REVISED AEROQUIP DESIGN:  
ALL DRAWINGS PREDATING  
THIS DRAWING ARE OBSOLETE

TOLERANCES: (UNLESS SPECIFIED OTHERWISE) .X = $\pm$ .030 .XX = $\pm$ .010 .XXX = $\pm$ .005 A/B = $\pm$ .0625 X' = $\pm$ 1'	DRAWN	DC	1/31/2011	University of Hawaii-SOEST	
	CHECKED				
	IMFG			TITLE	
	APPROVED			Quick Conect Handle	
	SIZE	B	DWG NO	QC-HandleRev1	REV
	SCALE				1
			SHEET 1 OF 1

**SECTION C-C  
SCALE 1**

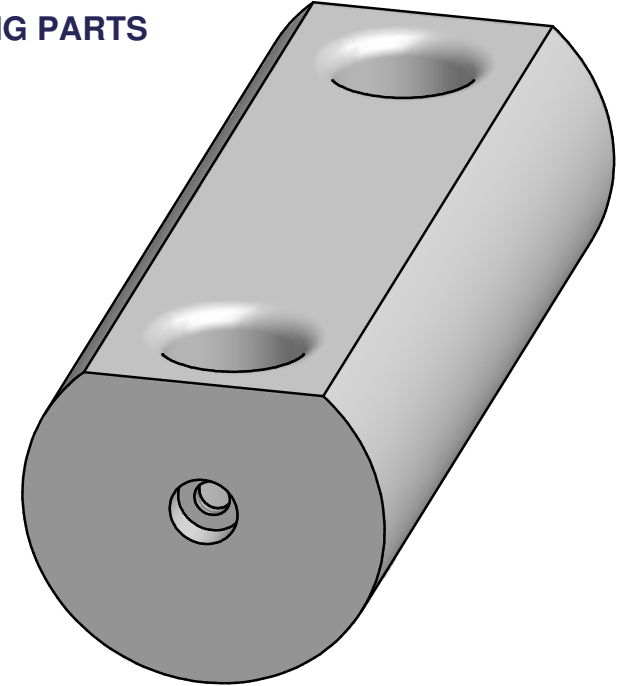
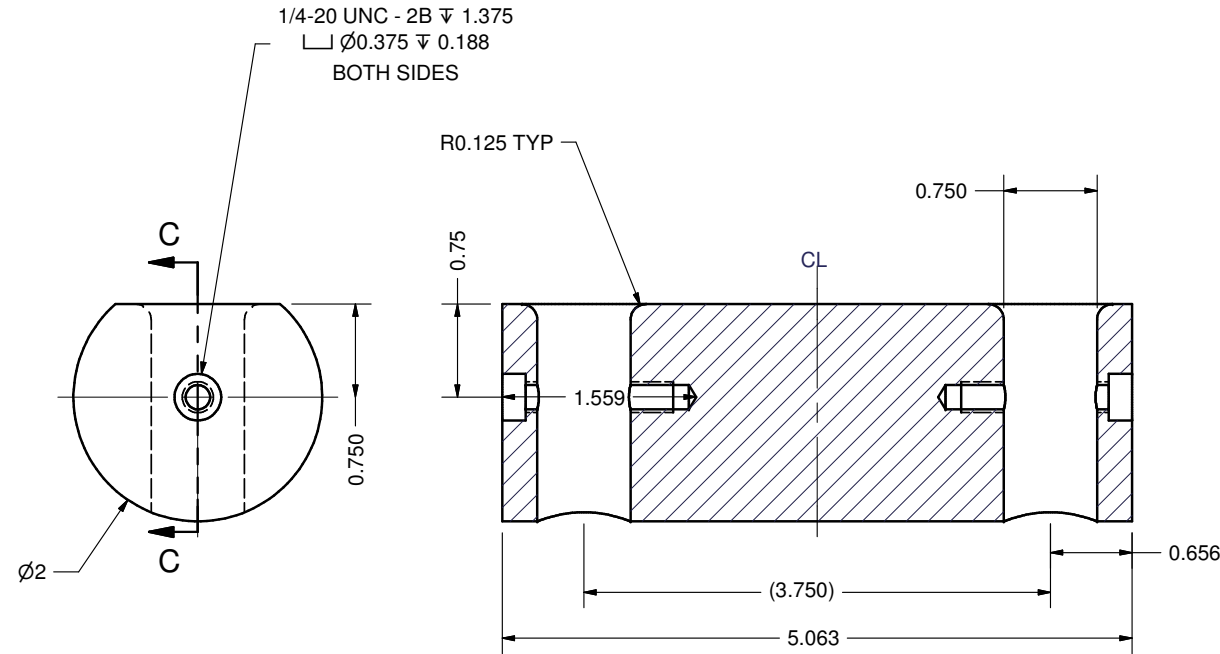
REVISION HISTORY				
ZONE	REV	DESCRIPTION	DATE	APPROVED
	1	ADDED .125 RADIUS TO PREVENT RISER TEARING	1/10/2011	
	1	FLAT ALL THE WAY ACROSS	1/10/2011	
	1

- NOTES:**  
**1) MATERIAL IS PVC**  
**2) ADD .125 RADIUS TO 5 EXISTING PARTS**
